Blueing the Caspian Sea

Review PIF and Make a recommendation

11429

GEF-8 PROJECT IDENTIFICATION FORM (PIF) REVIEW SHEET

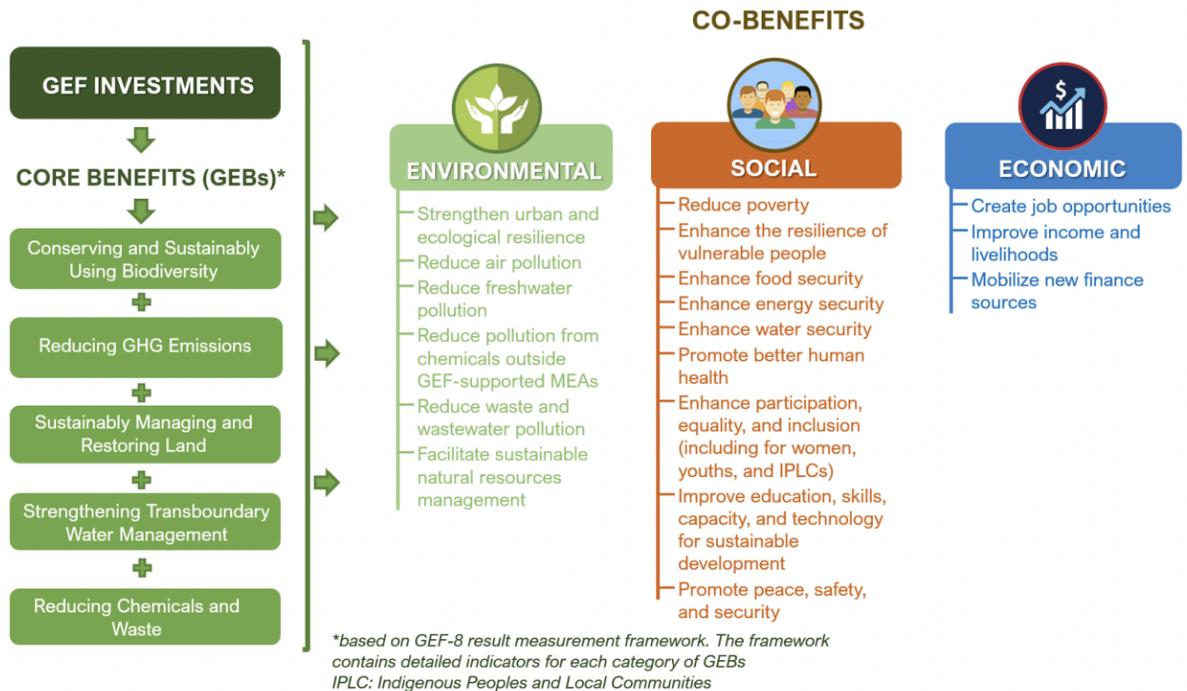
Should the text say " The following outputs are expected rather than "The following results are expected"

(4) Core indicators and their targets are now included in the Project Summary Section, along with explanation on direct beneficiaries - Text edited to reflect requested change
